AGENDA
VIRTUAL BIRMINGHAM DESIGN REVIEW BOARD MEETING
WEDNESDAY – February 3rd, 2021
******* 7:15 PM*******

MEMORANDUM

SUBJECT: 33202 Woodward – Piety Hill – Design Review (**All Updates in Blue Text**)

The subject site, 33202 Woodward, is currently home to a roughly 353 ft. long multi-tenant commercial building and associated building needs, such as 4 separate off-street parking facilities, trash receptacles, various tenant signage, and mechanical units. The applicant has submitted a design review application for an exterior renovation with no additional square footage added, some minor landscaping, and new lighting.

Conceptual
Site Plan

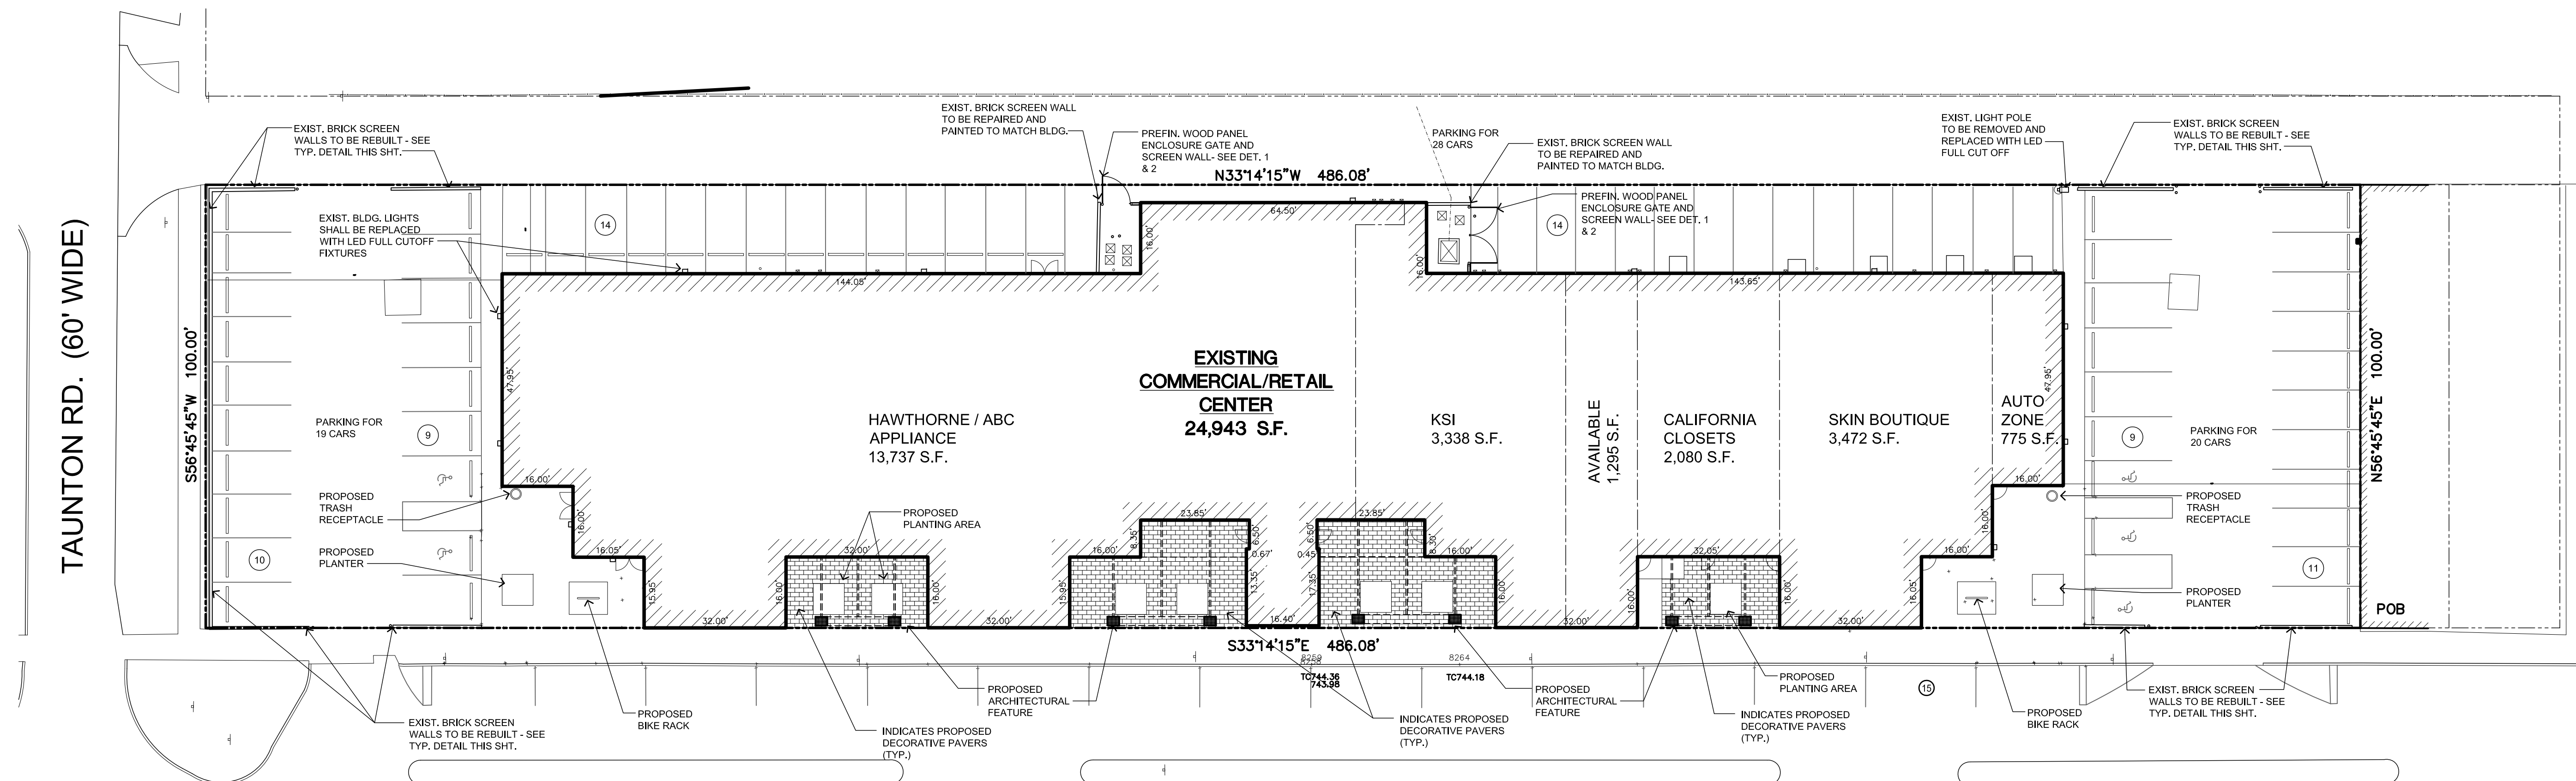
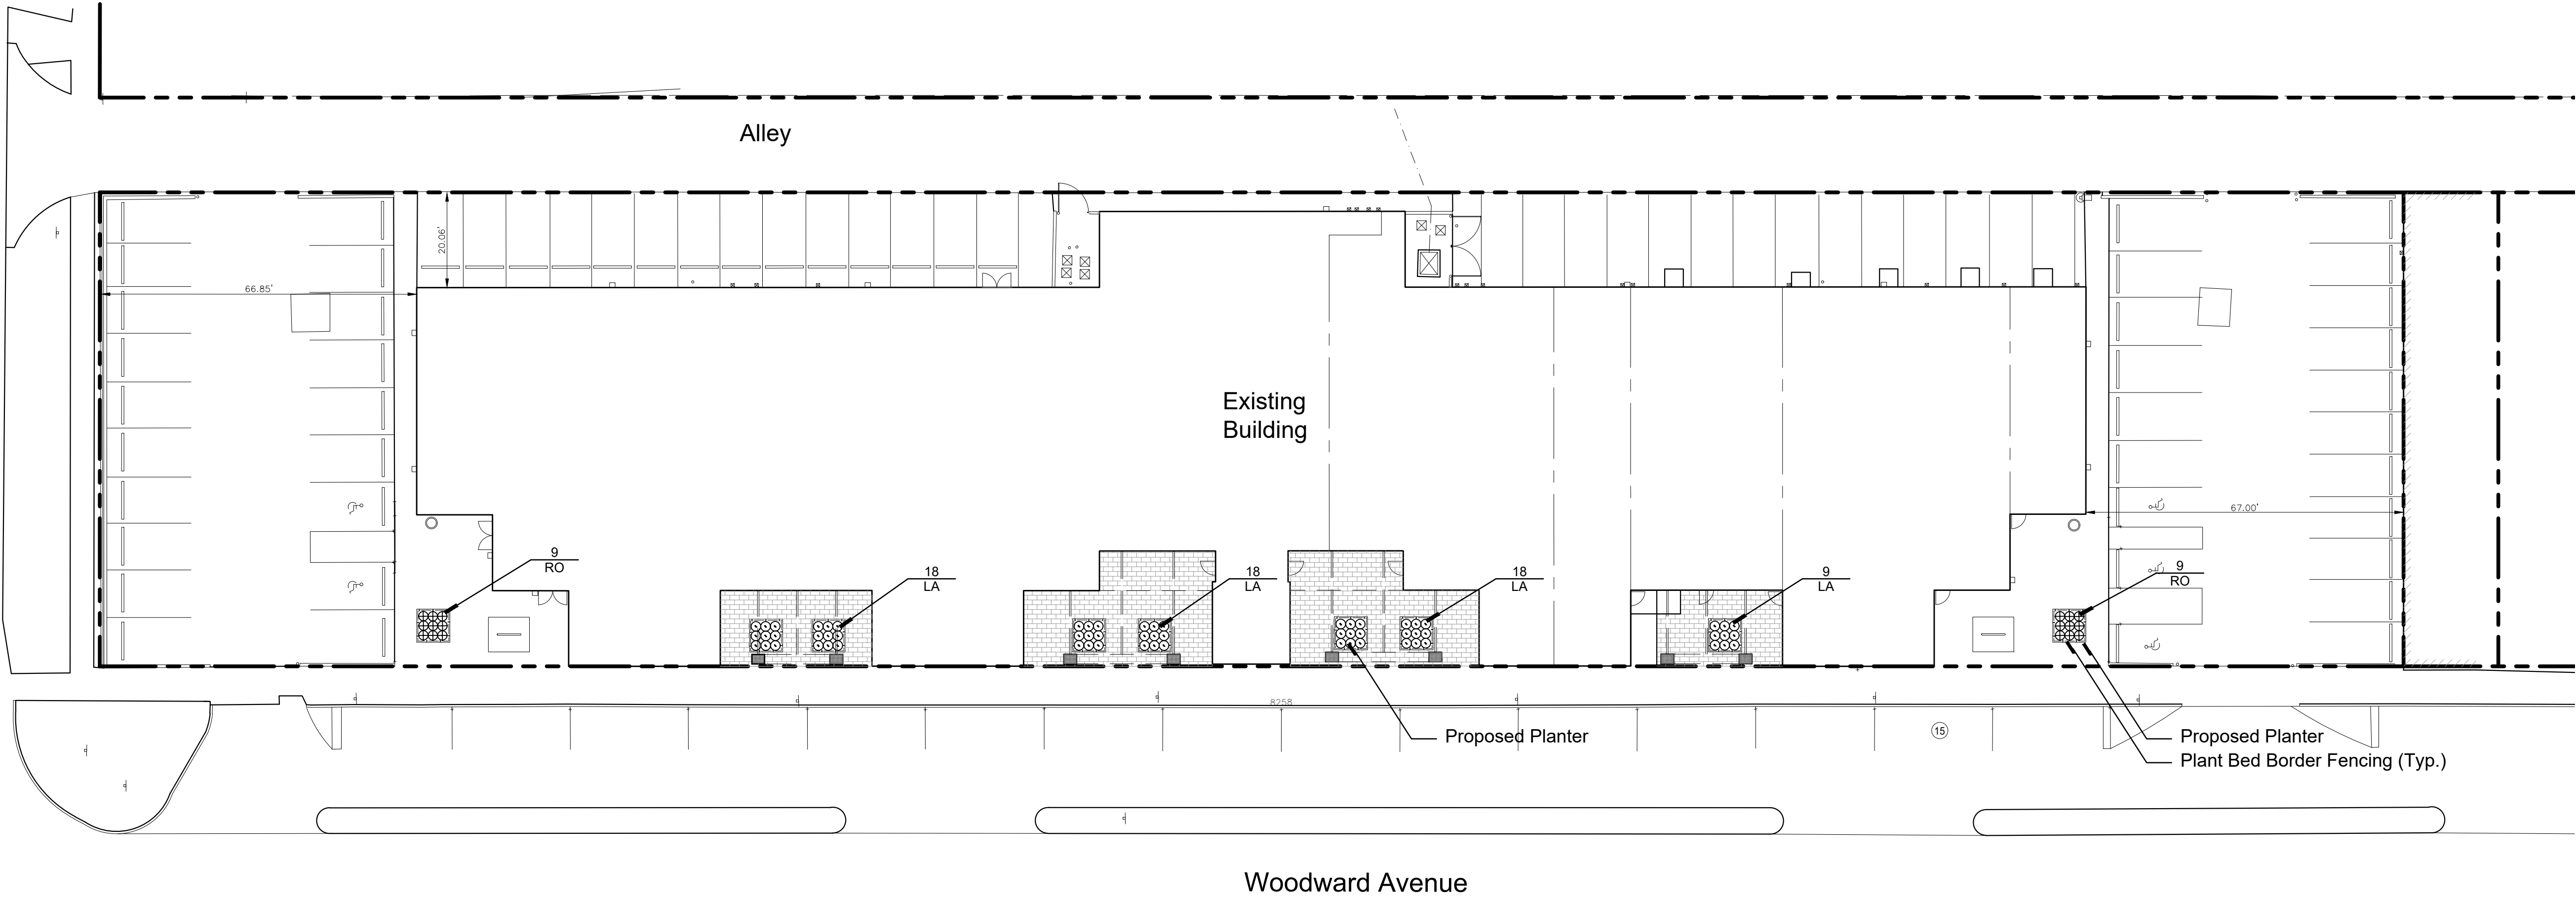
Although the current building and site would be considered legal-nonconforming when it comes to the parking requirements, the proposed building and site renovations include two new dumpsters and associated enclosures that force the removal of 5 parking spaces in the rear of the building. Article 4, Section 4.45 (A) states that:

Due to the existing non-conformance and the current proposal to increase the non-conformity, **the applicant must provide an additional 24 off-street parking spaces in compliance with Article 4, Section 4.45 (G), or obtain a variance from the Board of Zoning Appeals.**

The applicant has submitted revised plans that eliminate new dumpster enclosures and maintaining the current amount of legal-nonconforming parking spaces.

**Conceptual
Elevation &
Plan View**

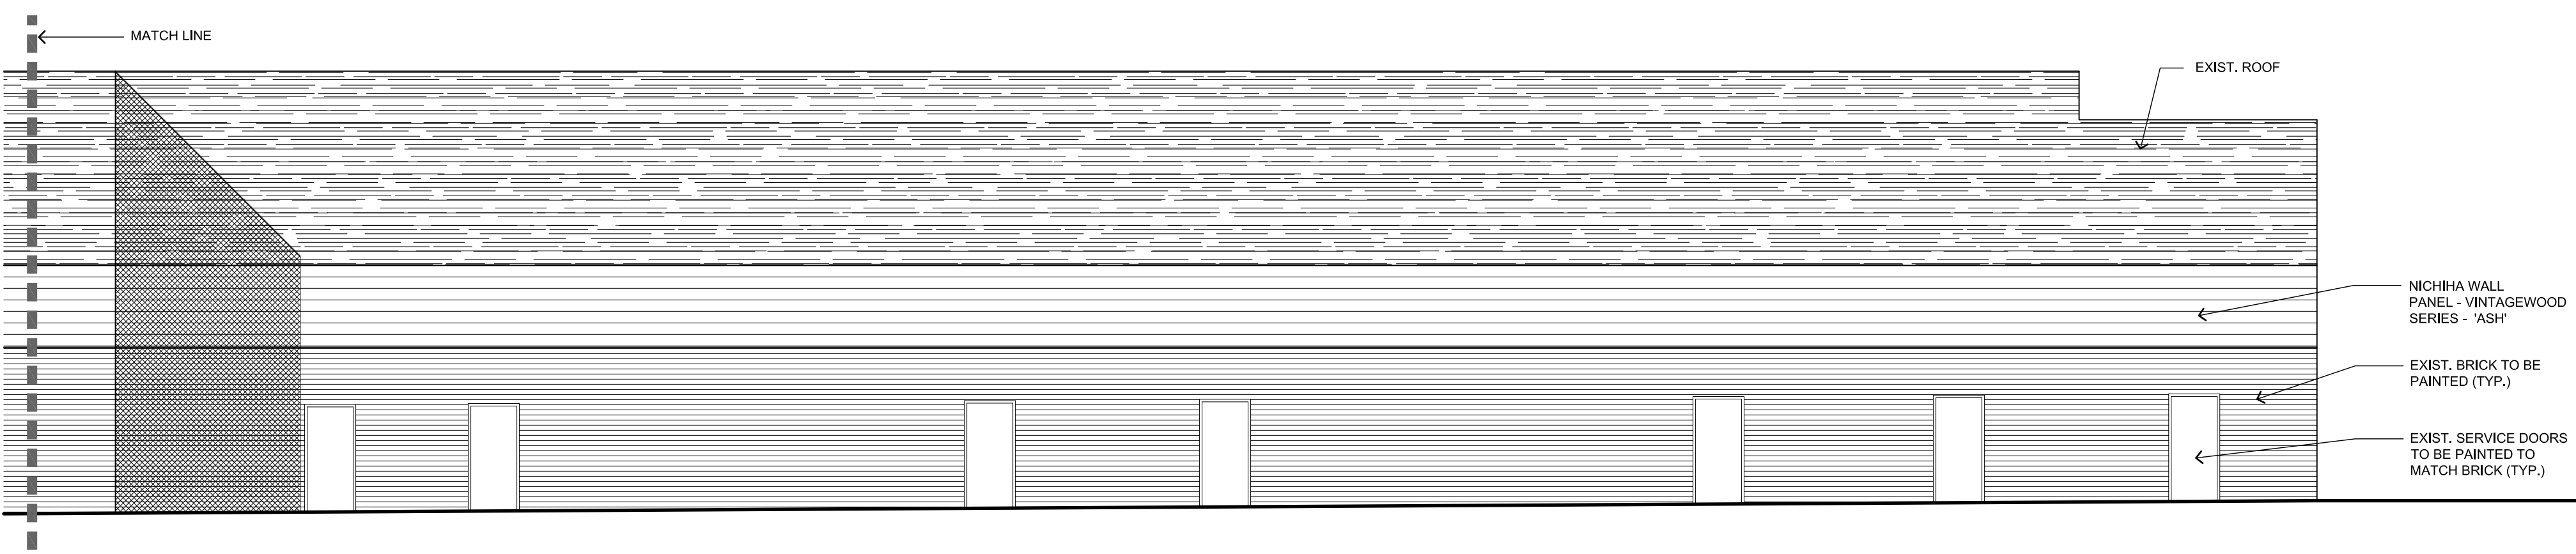
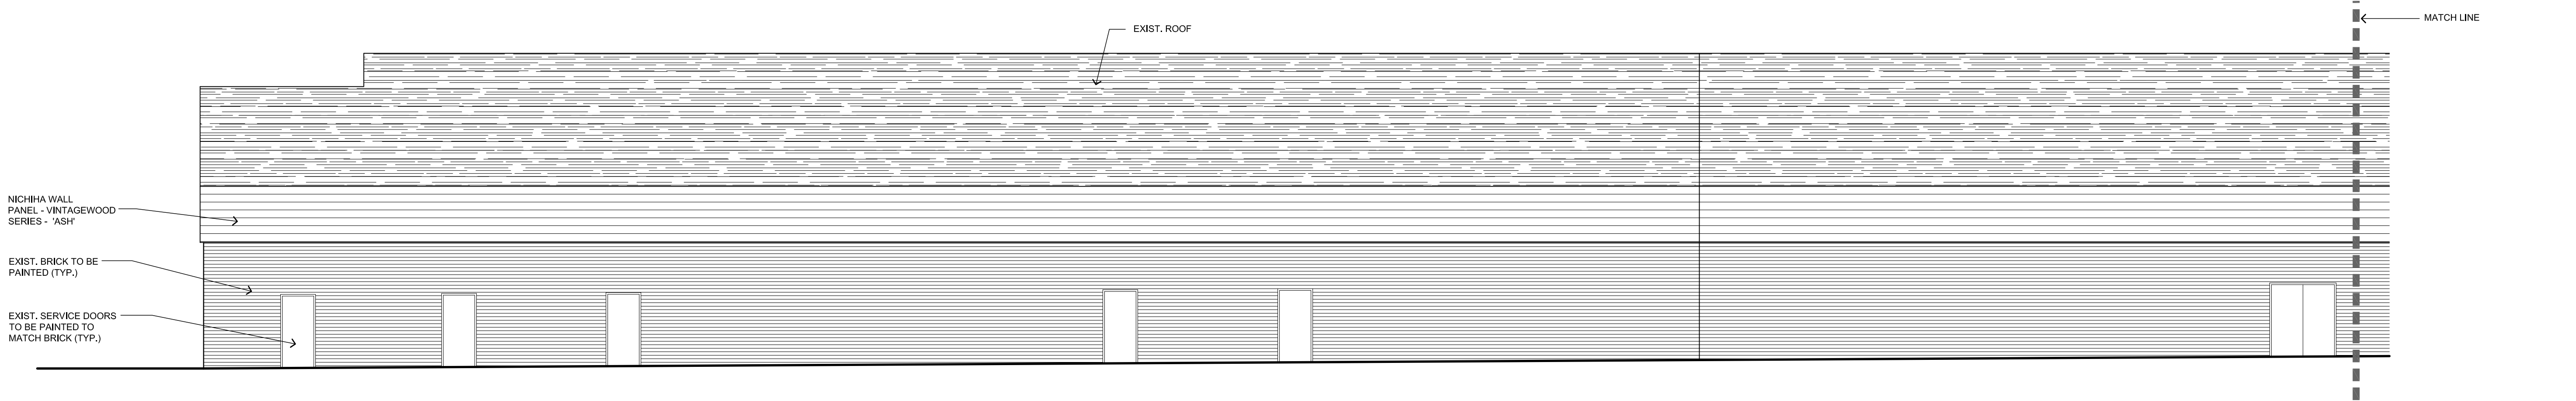
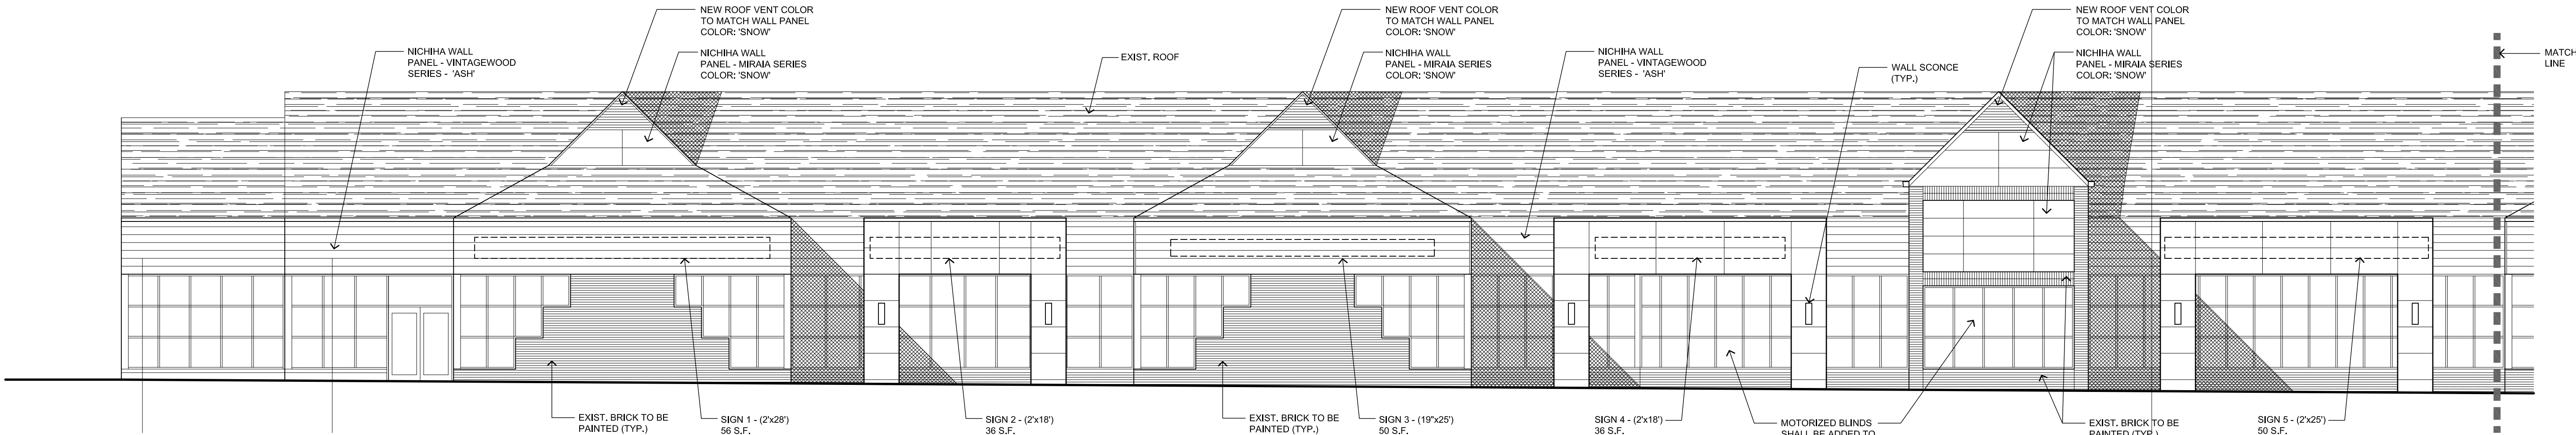
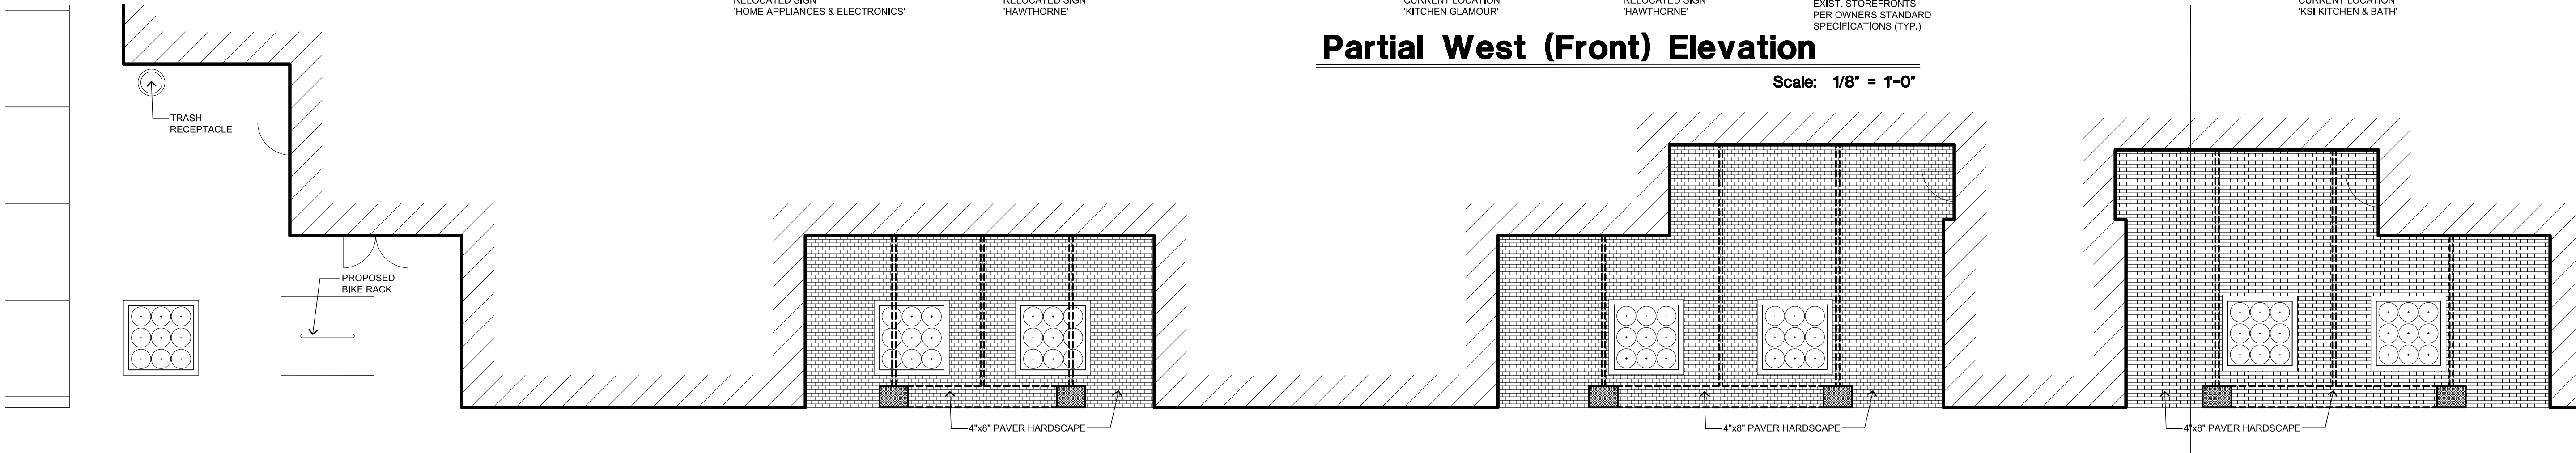
However, the elevation drawings provided contain a note at the northern tenant space windows that the storefront glass will be converted to spandrel glass. This type of change would constitute an expansion or modification of a legal non-conformity that would not be permitted. Not only would spandrel glass violate the 80% Visual Light Transmittance standard, it would also violate Article 4, Section 4.90 (A)(4) which states that windows shall not be blocked with opaque materials or the back of shelving units or signs. Although the current condition on site violates these standards, the applicant is not permitted to modify the windows unless they are brought up to the current standards. Thus, **the applicant must submit revised elevation drawings without modifications to the existing glass, propose new glass that meets the requirements of Article 4, Section 4.90, or obtain a variance from the Board of Zoning Appeals.**

The applicant is no longer proposing any modifications to the existing glazing.
